**Re: FortisBC Energy Inc. (FEI)**

**Application for a Certificate of Public Convenience and Necessity for the Inland Gas Upgrade Project (the Application)**

**Response to the Commercial Energy Consumers Association of British Columbia (CEC) Information Request (IR) No. 2**

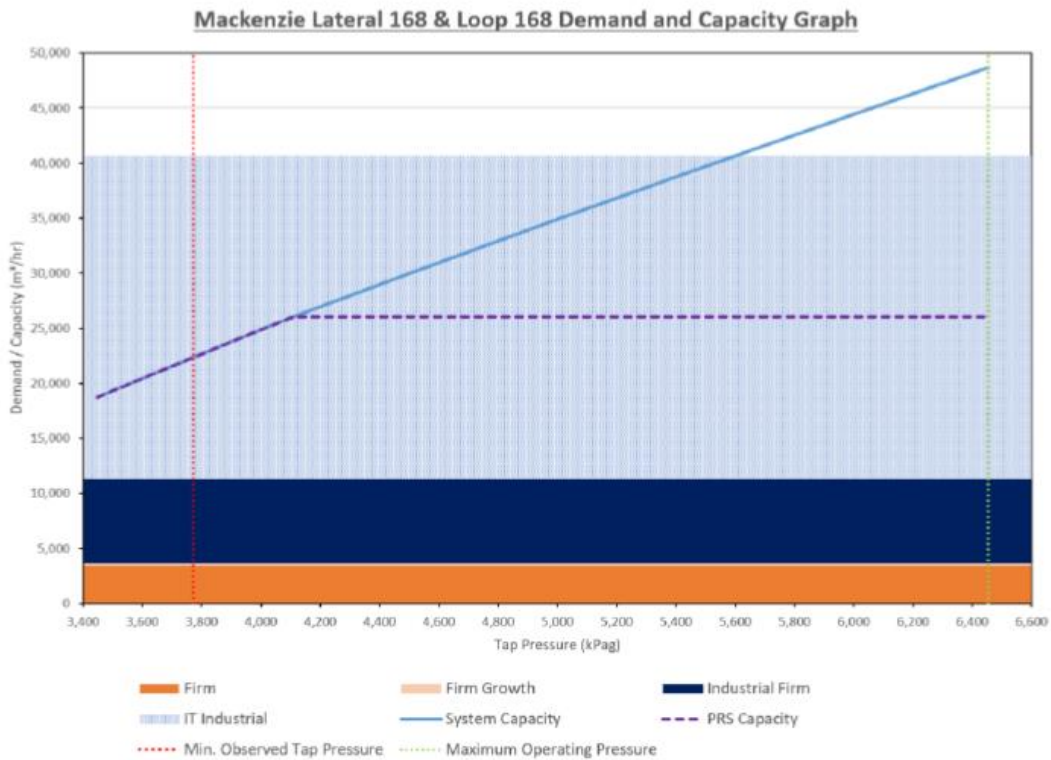
3           35.1   What pressures are considered to be ‘high pressure’ pipelines?

6   The referenced report (GRI-00/0189) does not contain an explicit definition of “high pressure”;  
7   however, Table 3.1 “Summary of relevant North American pipeline failure incident reports”  
8   includes incidents ranging from 497 psi (approximately 3430 kPa) to 1207 psi (approximately  
9   8320 kPa). The operating pressures of the 29 Transmission Laterals fall within this range.

Figure 2: Interior Dig Locations (64 active and 12 passive corrosion sites)

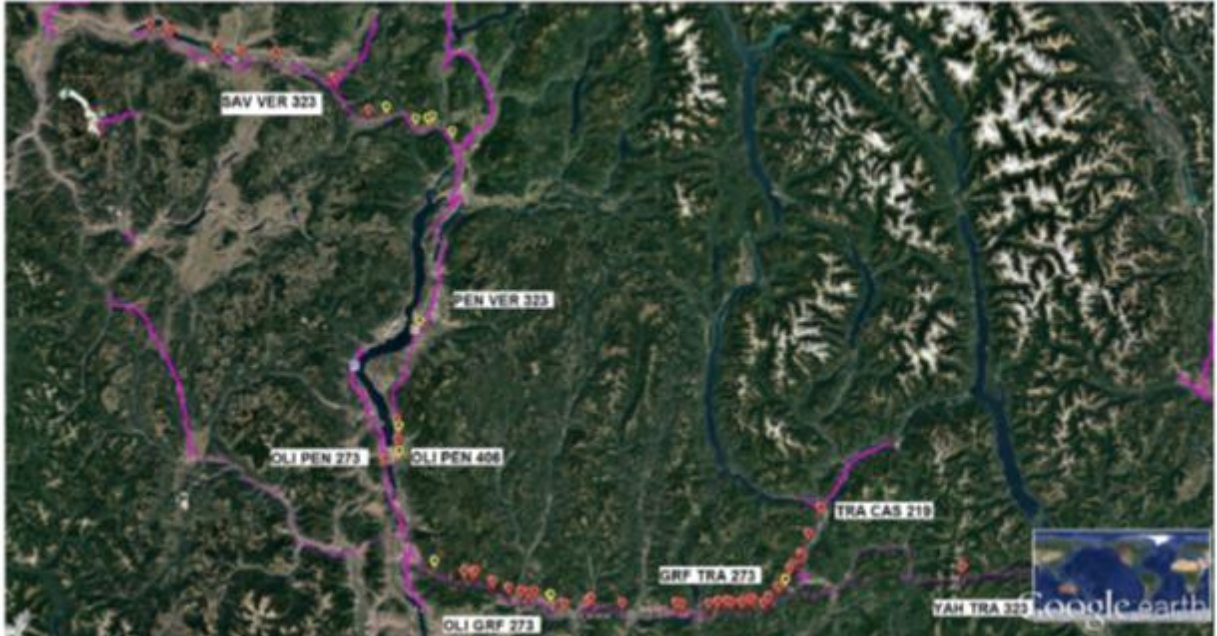
3            39.1    Please explain the difference between passive corrosion and active corrosion.

6    The term passive corrosion is used to describe corrosion (e.g. rust) on a pipeline that, based on  
7    the observations of a qualified analyst during an integrity dig, is considered to have occurred at  
8    some time in the past and is no longer actively progressing. The term active corrosion is used  
9    to describe corrosion that is considered to be growing at the time of observation.

10   Factors that could contribute to active corrosion becoming passive include changes to  
11   groundwater conditions or improvements to a previously sub-optimally performing cathodic  
12   protection system.
